APPLICATION FOR AMENDMENT TO PERMIT

REASON FOR PERMIT: Construct porch approx 30'x10'

RE: 83A-J-3,6 Crescent Avenue, Great Diamond Island

plot plan showing existing
structure.

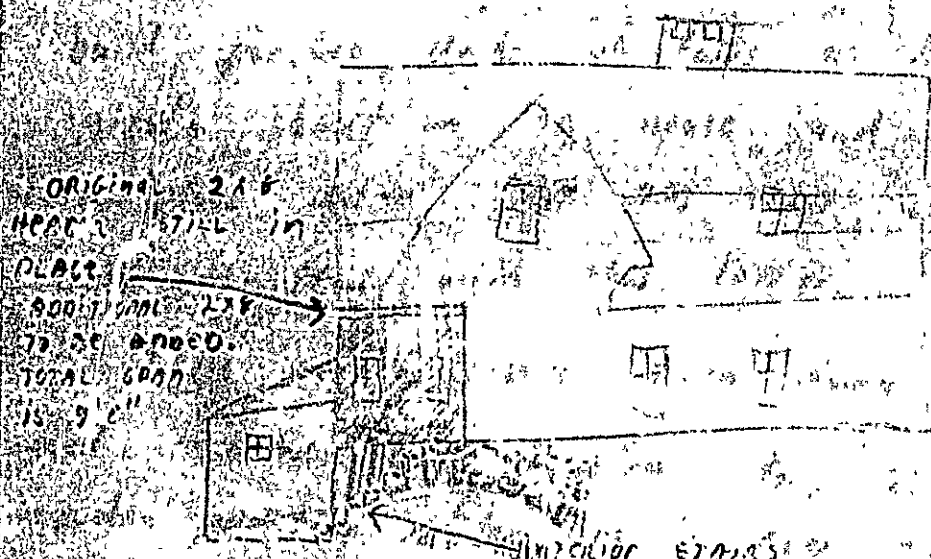
This letter is in reference to your application for an addition on Mr. Deletatsky's property on Great Diamond Island. The plot plan submitted does not show the proposed addition on the street frontage. Please provide this information so we may further process this permit.

This letter is in reference to your application for an addition on Mr. Deletetsky's property on Great Diamond Island. The plot plan submitted does not show the proposed addition on the street frontage. Please provide this information so we may further process this permit.

Came to office - Problem corrected.
§

Front elevation (south side)

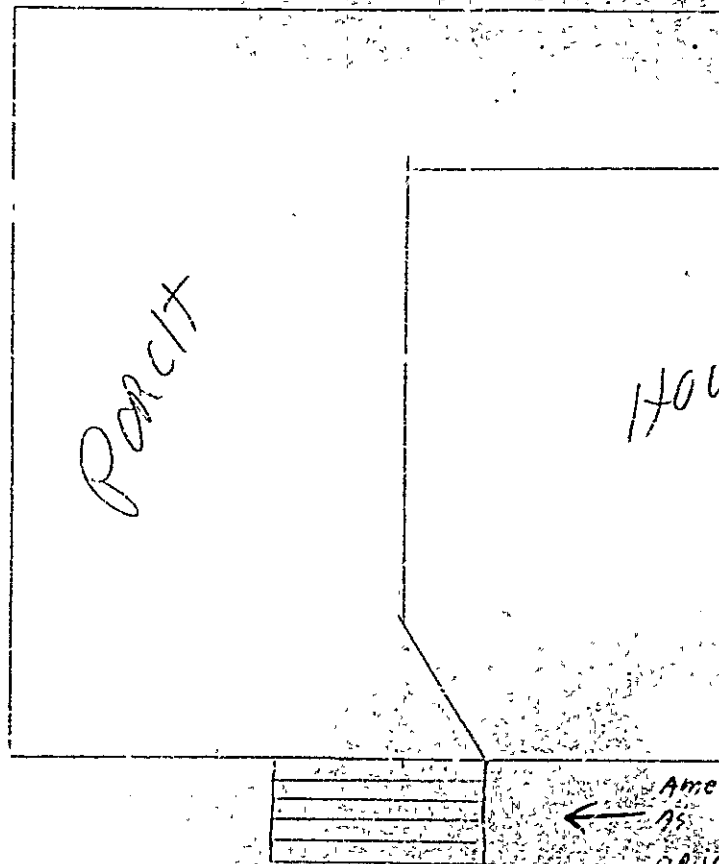
Amendment to build steps on a porch - steps were ~~XXXXXX~~ in plans, and deleted

Amend permit to add stairs
as drawn described on
original application
